FLOOR PLAN LEVEL 0
AREA H - AIR
DISTRIBUTION

PROJECT: 2016-0005 - PAUL VI CATHOLIC HIGH SCHOOL - AIR DISTRIBUTION - AREA H - LEVEL 0

1 LEVEL 0 - AIR DISTRIBUTION - AREA H
1/8" = 1'-0"

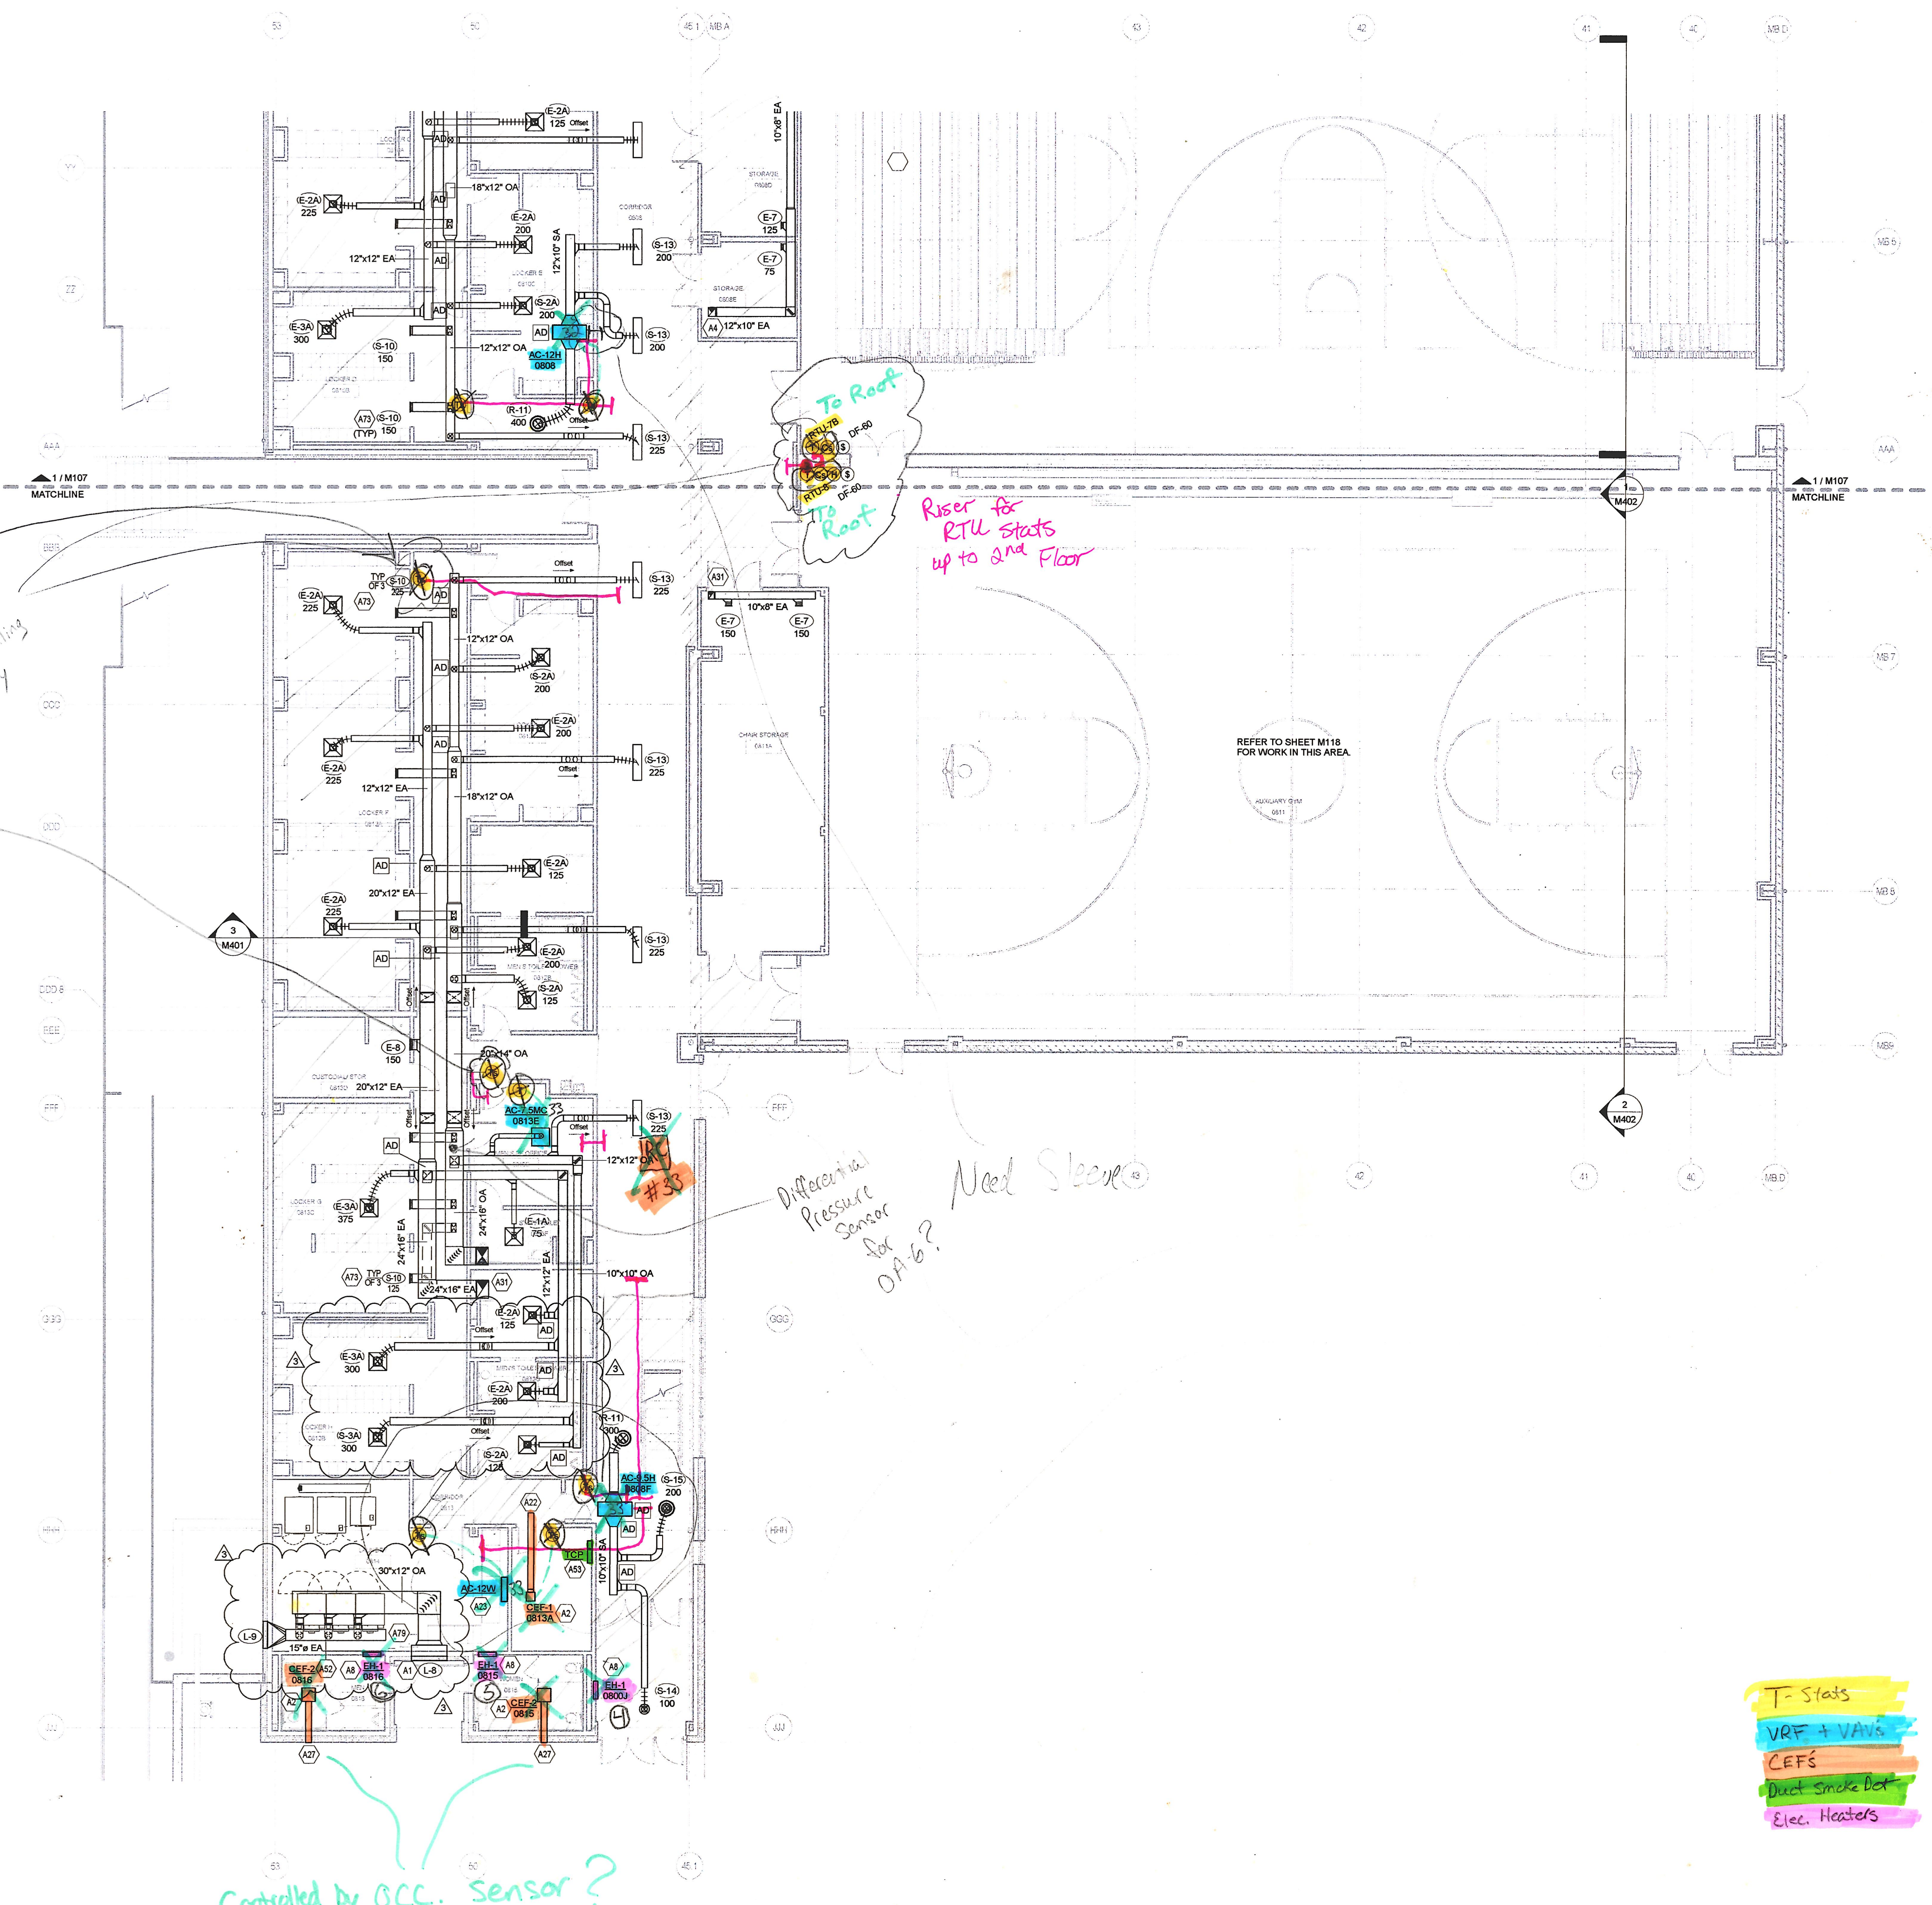
TS for OA-6
Extend pvc into drop ceiling hallway

To Roof
To Roof
Riser for RTU starts up to 2nd floor

Differential Pressure Sensor for OA-6? Need Sleeve

T-Stats
VRF + VAVs
CEFS
Duct Smoke Box
Elec. Heaters

Controlled by OCC. sensor?
